Appendix 10.1 – Consultation Record

From: Simon Waddell <[REDACTED]>
Sent: 03 February 2022 16:42
To: Nick Blowfield <[REDACTED]>
Cc: Emma Bathgate <[REDACTED]>
Subject: Nisthill Wind Farm - agreement of baseline noise survey approach

From: Simon Waddell
Sent: 22 April 2022 12:50
To: Nick Blowfield <[redacted]>
Cc: Kari Clouston <[redacted]>; Emma Bathgate <[redacted]>; Alasdair Baxter <[redacted]>; Gregor Massie <[redacted]>
Subject: Nisthill wind farm - agreement of approach to derivation of 'true' background and appropriate noise limits

Figure 1 – 35 dBL_{A90} contour and identified properties

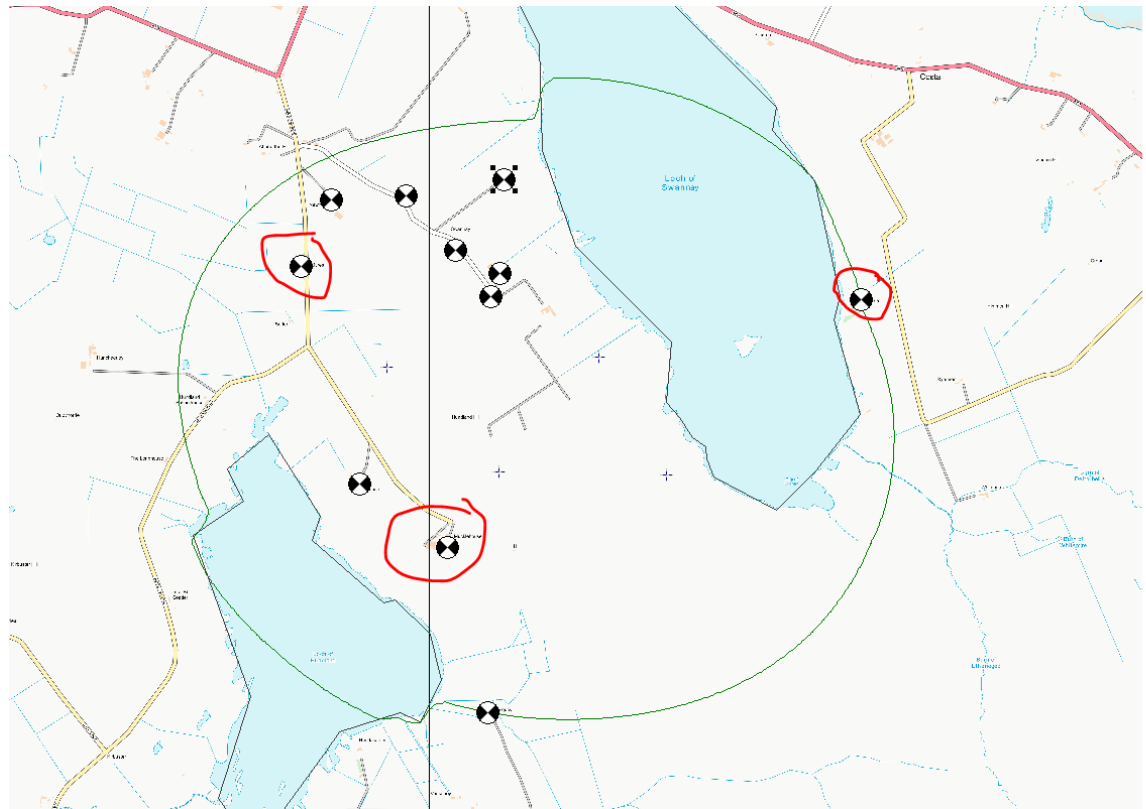
We have undertaken a preliminary noise model to identify properties and potential Noise Sensitive Receptors (NSRs) within the 35 dB contour, which I provide below as Figure 1.

The 35 dBL_{A90} contour is shown in green and properties are shown as black and white 'beachball' symbols, turbines are blue crosses. Not all of the properties shown are residential/inhabited – the status of all properties in the study area (residential/non-residential/financially-involved with the project) will be agreed with you at a later stage in the project.

Please note that ground absorption within the model has been set at G=0 for propagation over water for the lochs.

We propose to measure background noise levels in accordance with the requirements of ETSU and the Institute of Acoustics' Good Practice Guide (GPG) at three locations. Potential monitoring locations are circled in red in Figure 1, however, our final selection will be determined according to residents' consent to access properties and conditions encountered while on site.

Thank you for your email. Having read through the information provided I have no concerns or questions regarding the installation.

Figure 1 – NMPs and existing turbines

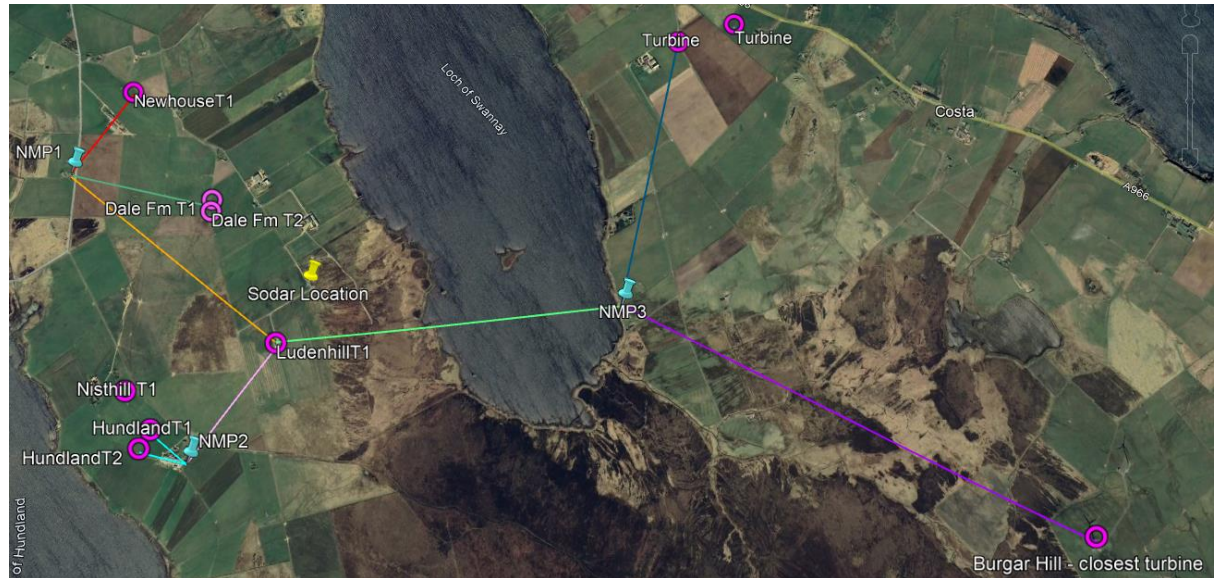
As previously discussed, we measured background noise levels at three NMPs within the predicted 35 dBL_{A90} noise contour of the proposed development. The NMPs and the existing wind turbines are shown in Figure 1.

- As previously reported, the sound level meter (SLM) was installed to the west of the building at Myres and, as such, we consider that it would have been screened from noise from the Ludenhill turbine (orange line on Figure 1 shows distance of 1,250m between NMP1 and Ludenhill turbine) – predictions support this. No correction has therefore been applied to measured background noise levels in the derivation of representative background noise levels in the absence of the Ludenhill turbine.

- The Dale Farm turbines (T1, T2) are approximately 660m from the NMP (green line) and were screened by the building – no correction has therefore been applied to measured levels for these turbines.

- The Hundland turbines (T1, T2) and Nisthouse turbine are between 1.1km and 1.3km from NMP and will have a negligible contribution to measured background levels. No correction has been made for these turbines.

- There is an Evance 9000 turbine at Newhouse (shown as ‘NewhouseT1’) which is 440m from NMP1. This turbine has been modelled and the predicted noise level from this turbine (predicted in accordance with the IoA GPG at a receptor height of 4m above ground level) from logarithmically subtracted from the measured background levels recorded at NMP1 for each wind speed. No directional filtering has been applied.

Apologies for the delayed response having read through your email , in general the approach is considered acceptable, however I do have concerns regarding 'Stage 8' and the proposal of slight variation to relax the process due to financial benefit. What is proposed may be acceptable if it were known to what extent the residents of NSR6 and NSR8 financially benefit?

Figure 2 – close up of NMP1

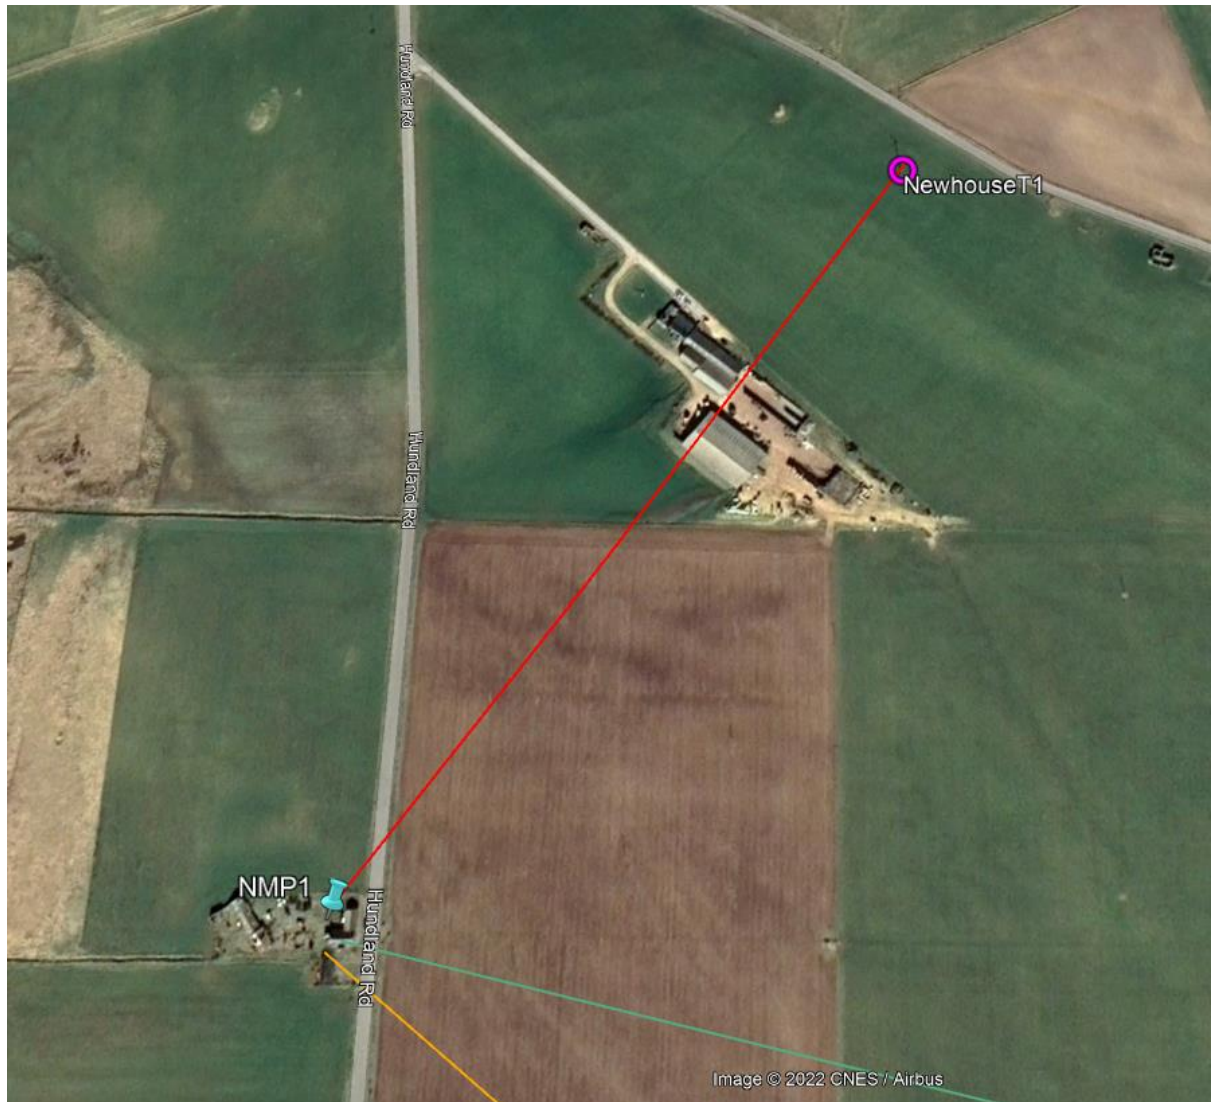
Close up of the NMP provided in Figure 2 showing orientation of closest existing turbine.

Figure 3 – close up of NMP2

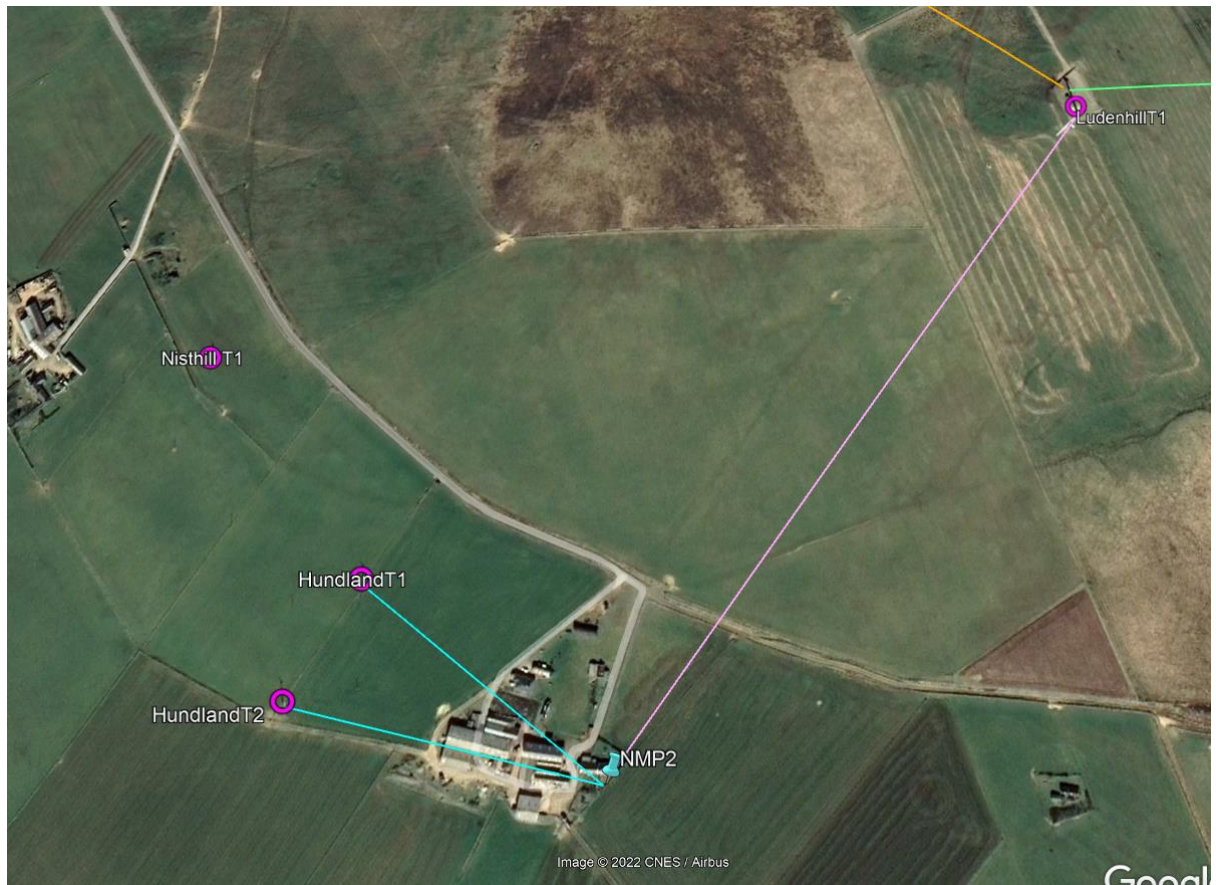
- *As previously reported, the sound level meter (SLM) was installed to the south-east of the buildings at Hundland and, making use of the farm buildings and topography to screen noise from the nearby Hundland turbines and Nisthill turbine (light blue lines on Figure 1 show distance of 200m between NMP2 and the Hundland turbines) – predictions which consider screening due to buildings support this. No correction has therefore been applied to measured background noise levels for noise from these turbines.*

- *Noise from the Ludenhill turbine 600m to the north has been predicted at NMP2, excluding any screening from buildings (a robust approach, as the NMP was on the opposite side of the house from the turbine) and the predicted level logarithmically subtracted from measured background noise levels for each wind speed. There is no reported sound power data for the Ludenhill turbine for 4m/s wind speed, so the 5m/s value was used at 4m/s – this is considered a robust approach.*

- *Noise from other turbines is considered to be negligible at NMP2 based on separation distance.*
- *No directional filtering has been applied to the data.*

Close up of the NMP provided in Figure 3 showing screening of NMP from the Hundland and Nisthill turbines by farm buildings.
